**NZ 37/05 PAPUA NEW GUINEA - New Britain to Hankow Reef - Depths.**

**Chart NZ 14060 (INT 60) [35/05]**

**Chart NZ 14604 (INT 604) [27/04]**

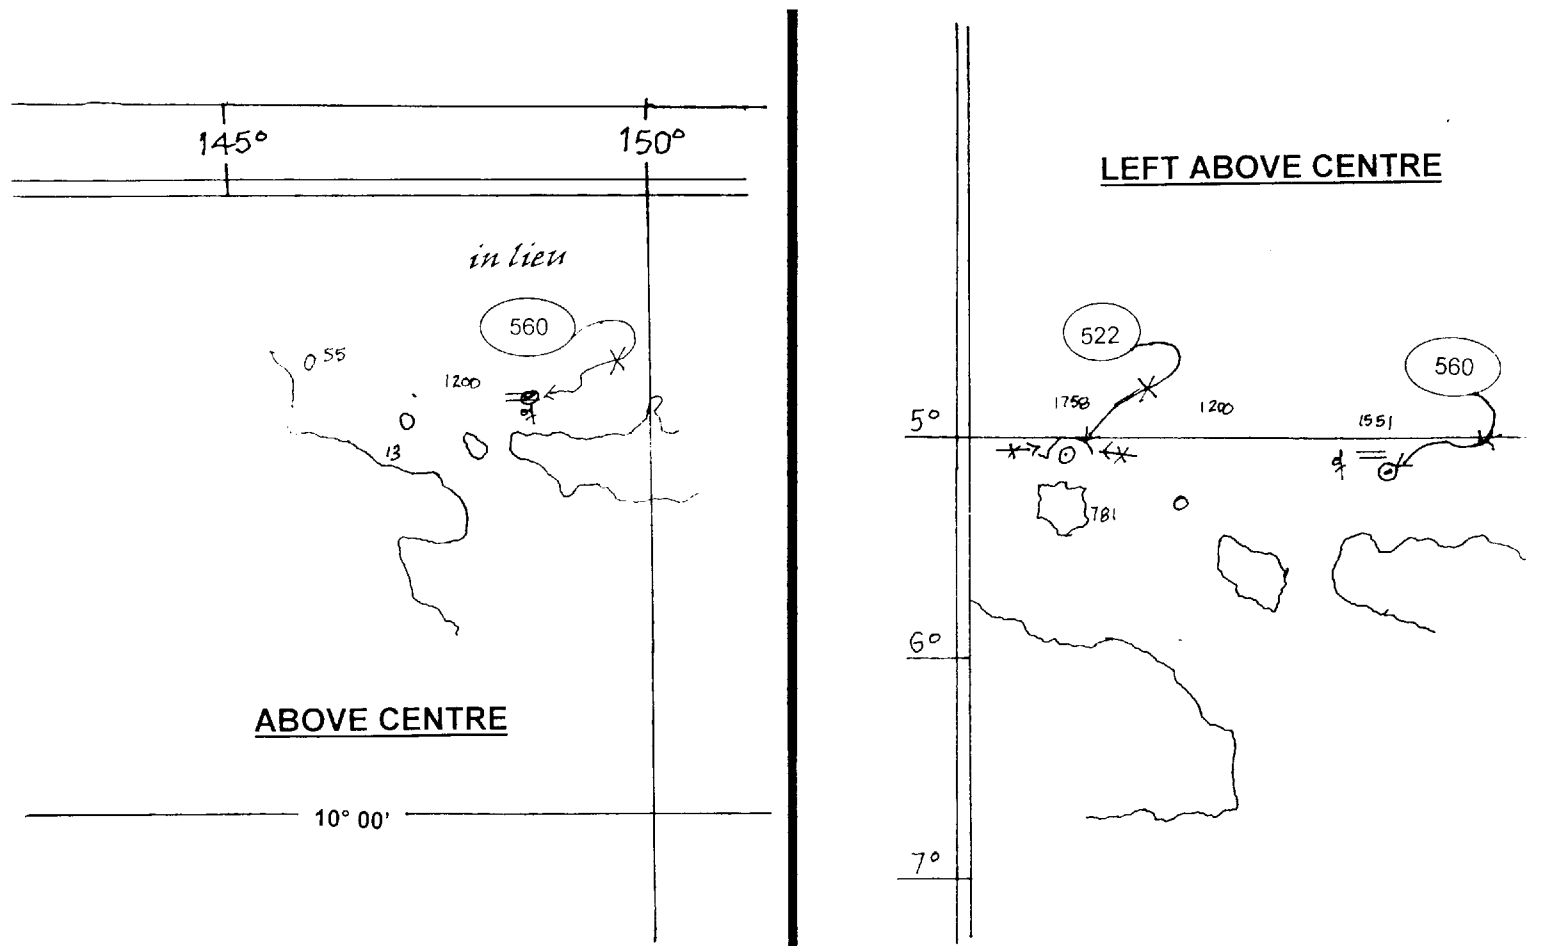
Insert depth, 560 m 5° 09'.0 S 148° 34'.6 E  
 depth, 522 m, and extend contour N to enclose 5° 05'.3 S 147° 06'.5 E

Delete depth 759m 5° 04'.9 S 148° 29'.0 E
